Amendment No. 0001
28 January 2002

SUBJECT: Amendment No. 0001 to Specifications and Drawings for Construction of
REPLACE SECONDARY ELECTRICAL SERVICE - LINE 3A at IOWA AAP, IOWA
Solicitation No. DACA45 02 B 0004.

b. Drawings (Not Reissued). The following drawing sheets of drawing code F 812-42-01 are revised as indicated below with latest revision date of 28 January 2002. These drawings are not reissued with this amendment.

SKETCH No. Z
Am# 0001

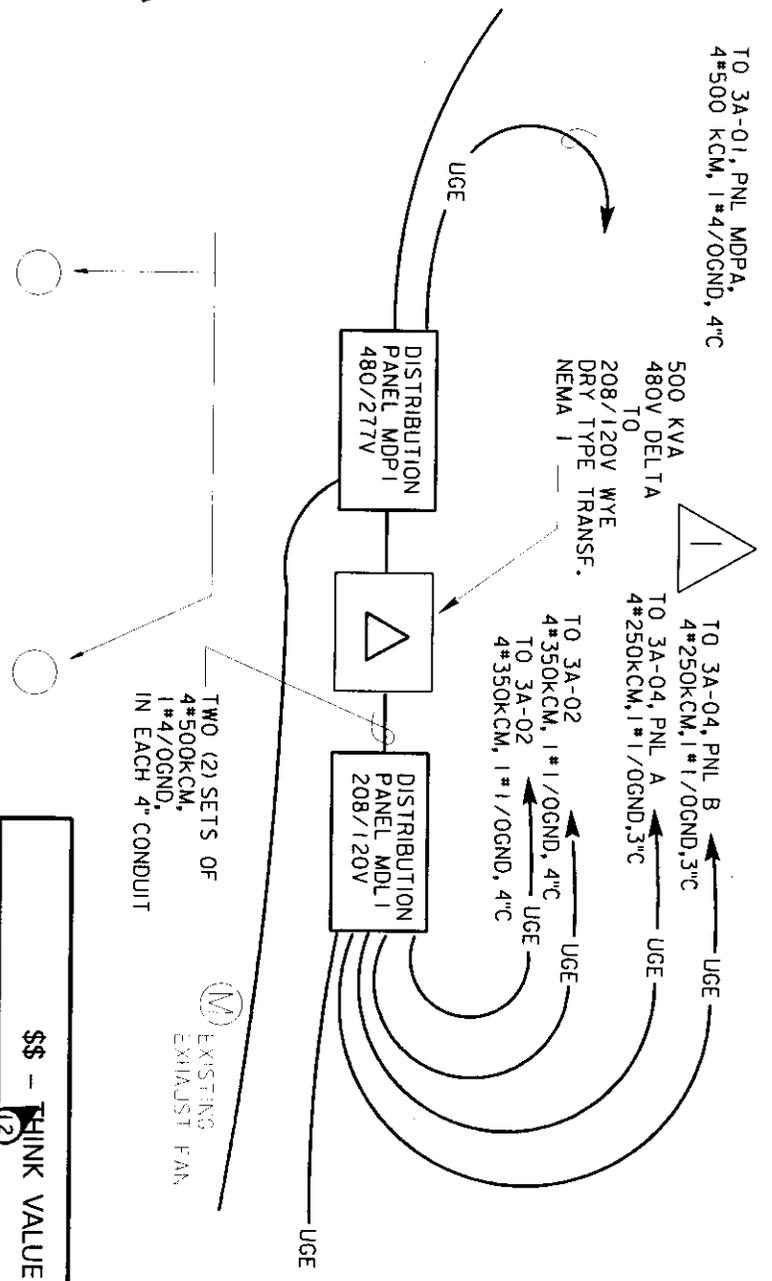
"WHEN NEW POWER SYSTEM IS OPERATING FROM 3A-03-1, DISCONNECT PANEL AND TRANSFORMER AND ABANDON IN PLACE"
 - (8) **SHEET E.7**, Revise sheets in accordance with attached Sketch Nos. 1 and 2
 - (9) **SHEET E.9A**, Title block delete "INFORMATION DRAWING (PHOTOGRAPHS)" and substitute "BUILDING 3A-03-1 (PHOTOGRAPHS)".
 - (10) **SHEET E.11**, Revise in accordance with attached Sketch No. 3
 - (11) **SHEET E.12**, At drawing coordinate 4B, center top of sheet,

*SKETCH No. 4
Am # 0001*

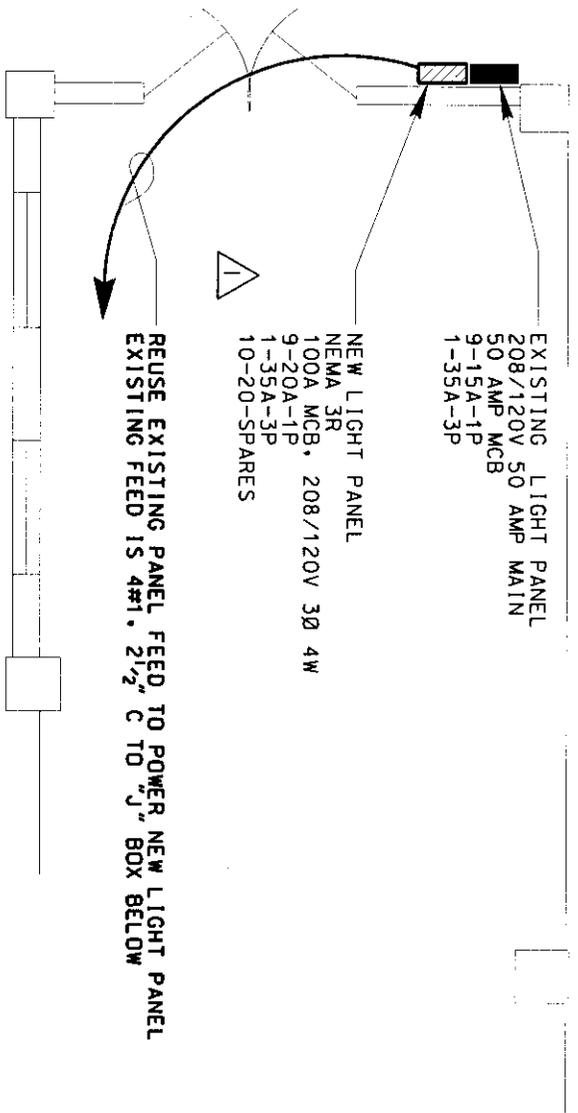
(12) SHEET E.14, Revise in accordance with attached Sketch No. 4.

SKETCH NO. 16
 AM # 20701

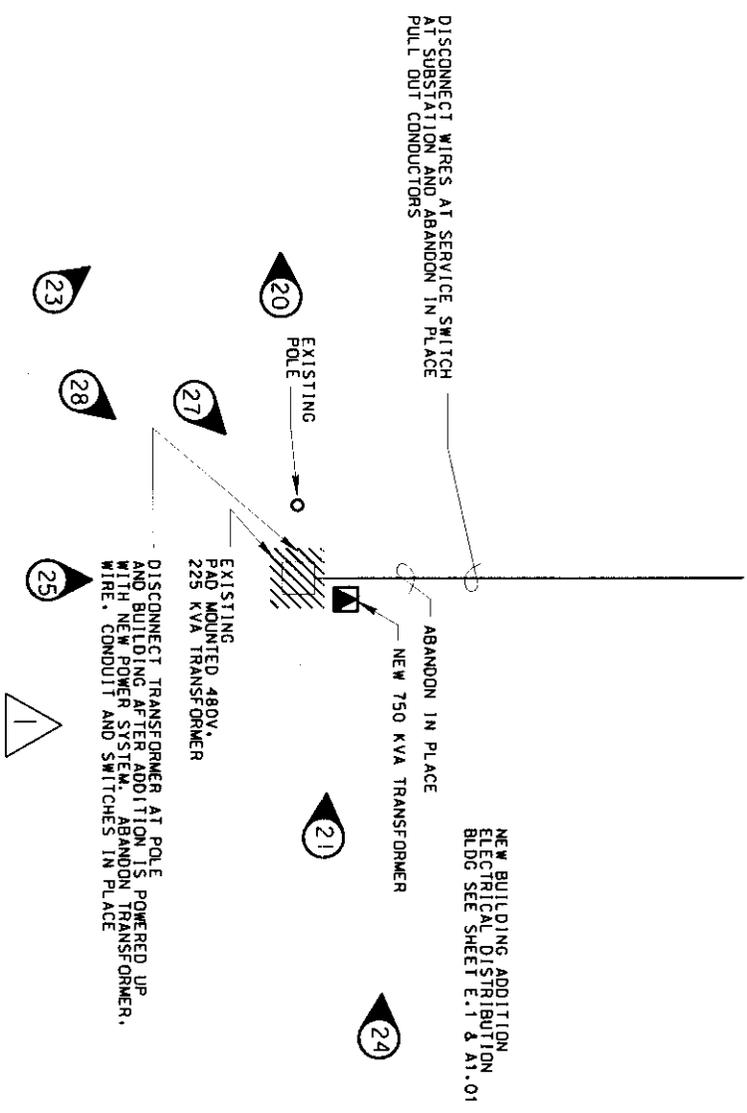
(16) SHEET E.17, Revise in accordance with attached Sketch Nos. 5
and 6.

SKETCH No. 7
Ava # 1000 1

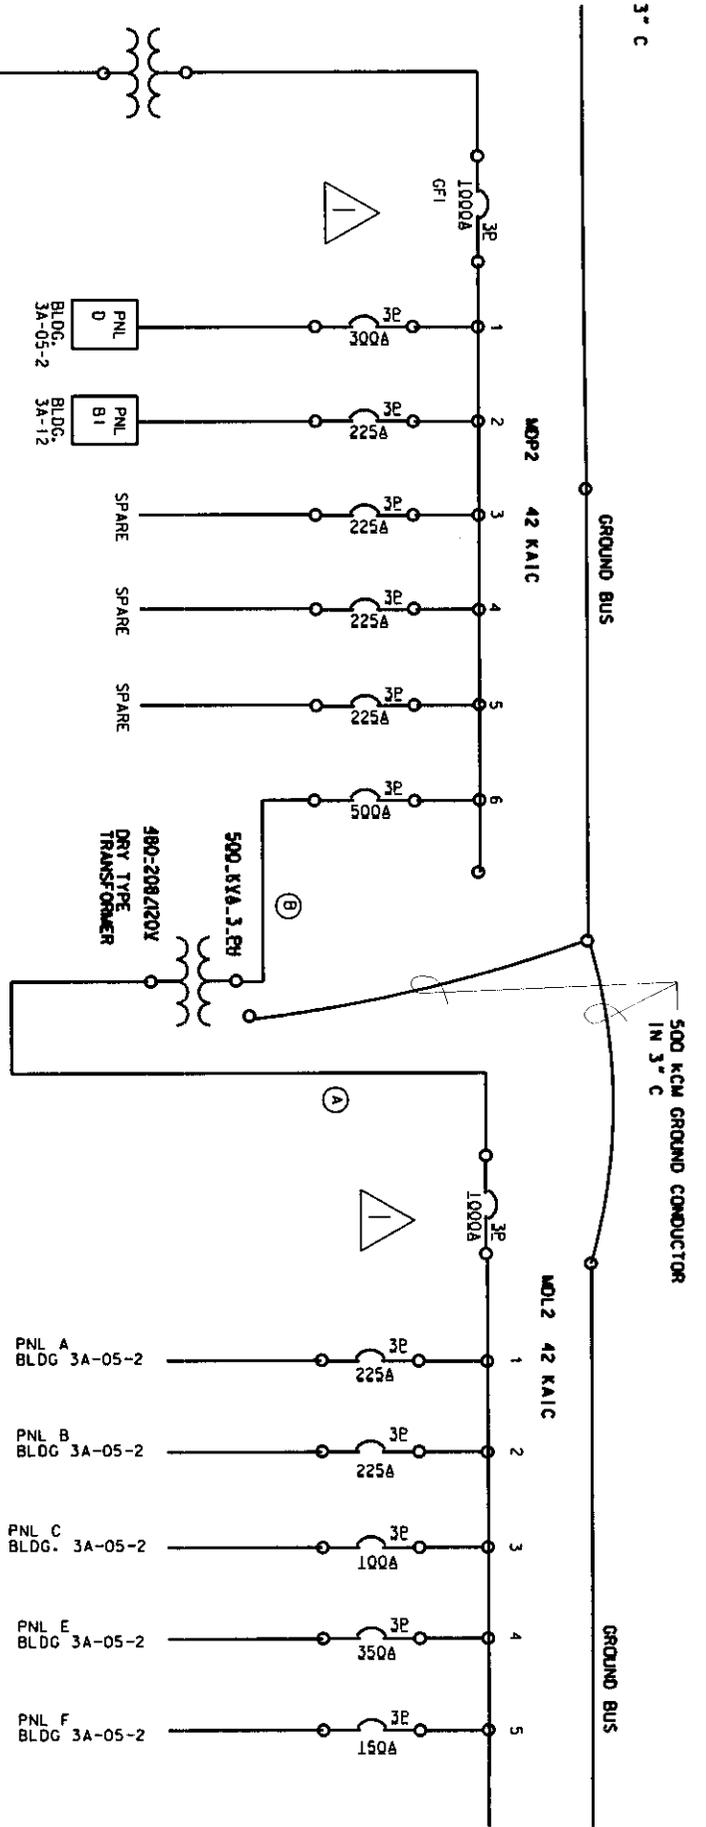
(17) SHEET E.21, Revise in accordance with attached Sketch Nos. 7

SKETCH No 8
AMH 10/20

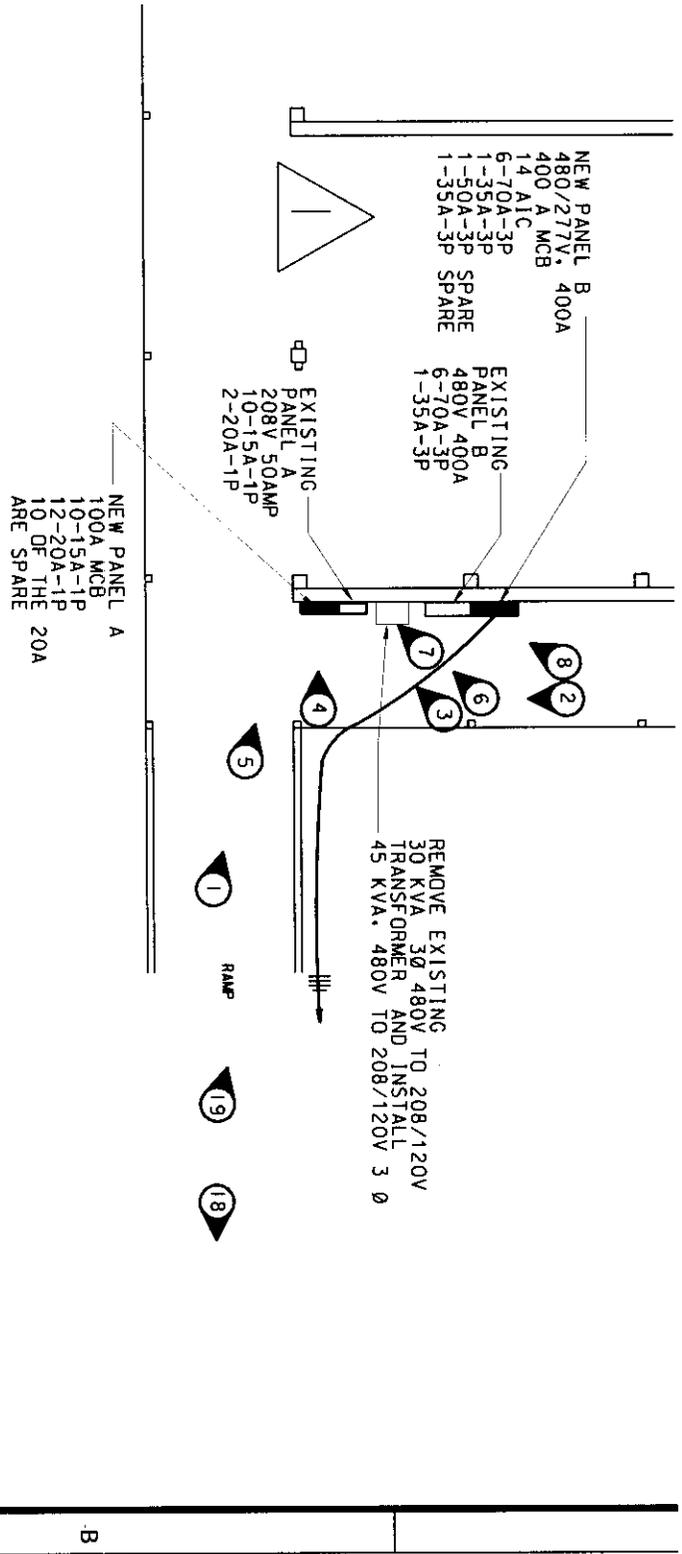
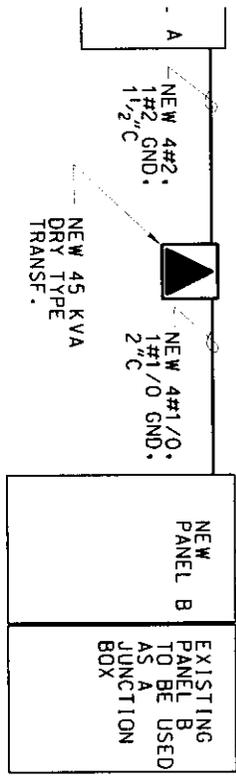
(19) SHEET E.25, At drawing coordinate 4B, bottom left sheet,
delete "EXISTING 4#500kCM TO MDP1 IN 3A-050-1E SEE PHOTO #9
SHEET P5.03 AND P5.06" and substitute "EXISTING 4#500kCM IN
JUNCTION BOX TO MDP1 IN 3A-05-1E SEE PHOTO #9, SHEETS P5.03
AND P5.06, AND SEE SHT E.26 FOR BREAKER SIZE".

(20) SHEET E.25, Revise in accordance with attached Sketch No. 8
